SUBJECT: W.P. 255-62 Site 29-13
Sherwood River Bridge
6.0 miles south of north Jct. Hwy. 62,
Secondary Hwy. 521,
District #10.

Sherwood River Bridge, Hwy. 521, District #10,
W.P. 255-62 - Site #29-13 - W.J. 65-F-55

Re: Hwy. 521. W.P. 255-62. Sherwood River Bridge.

FOUNDATION INVESTIGATION REPORT

| SURVEY BY Chief of Party - D. DOWDALL Supervisor - C. BAKER | DRAWN BY Draftsman - G. MARTIN Supervisor - G. BROWN | PLAN No - E-4603-1 |

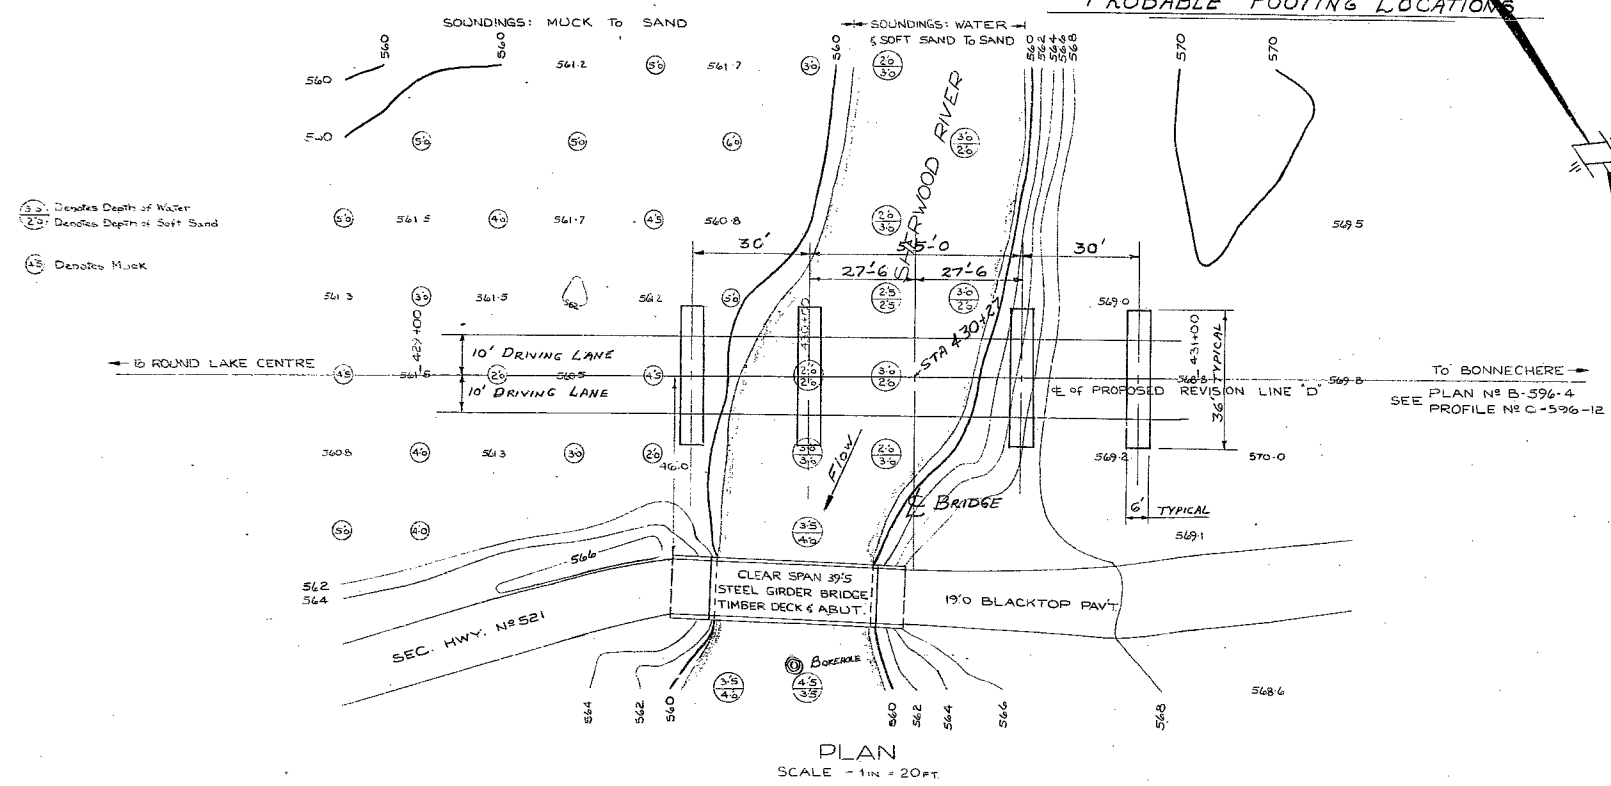
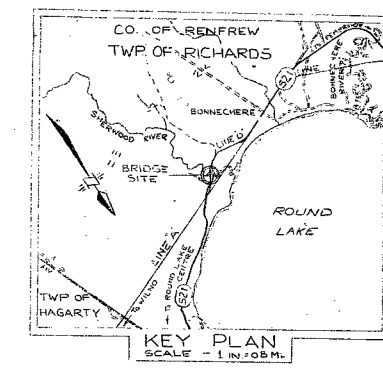
Would you kindly arrange to have a foundation investigation conducted at the above location. I have enclosed two copies of the site plan number E-4603-1 with the probable footing locations marked in red. Would you also have an additional boring made at the point indicated by a red circle, so that we may get some idea of the scour that has taken place in the past.

| D-5777-P1 | | | |

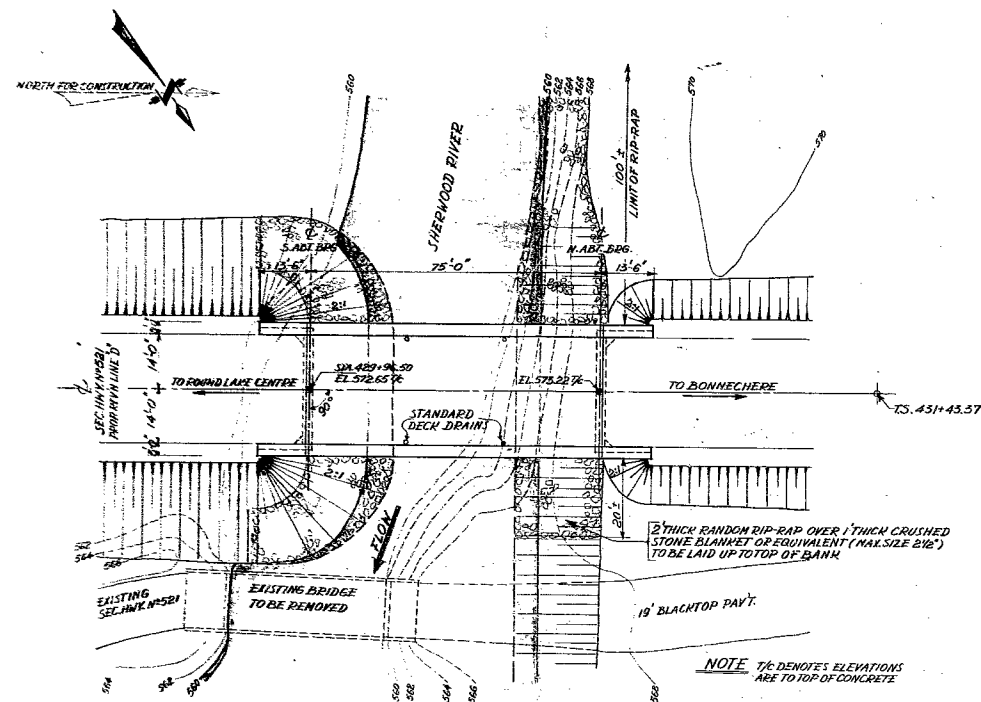
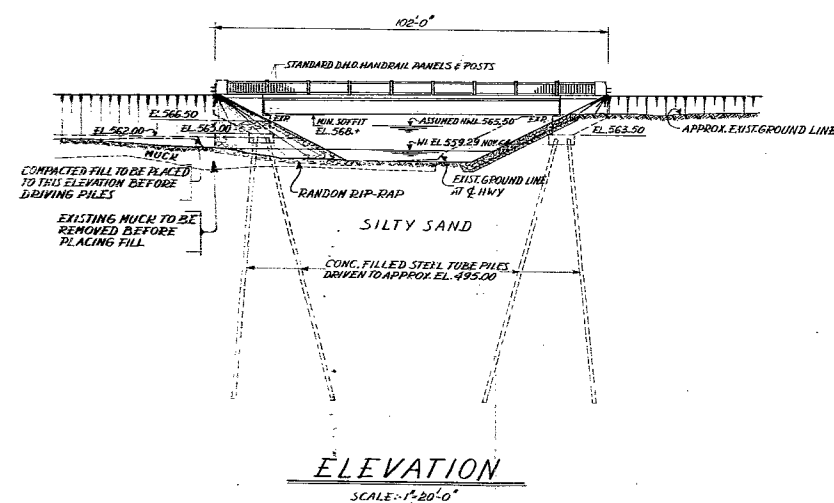
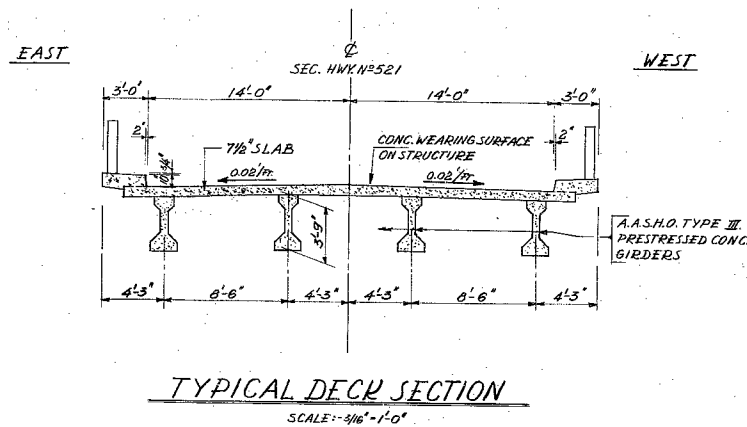
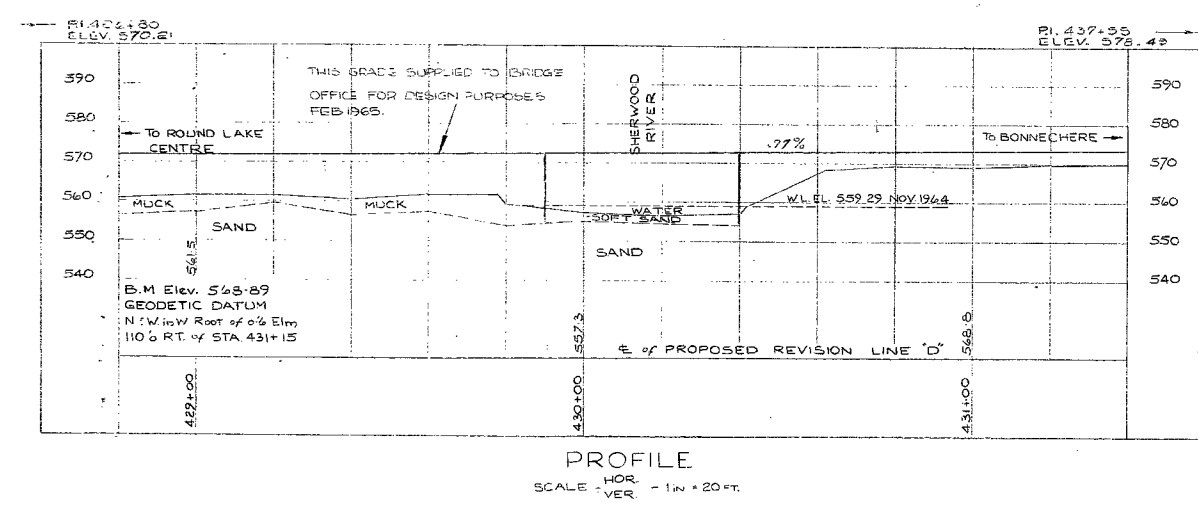
We have reviewed Preliminary Plan
No. D-5777-P1 for the above-mentioned structure.
The foundation design appears to comply with
recommendations contained in our Foundation Report.
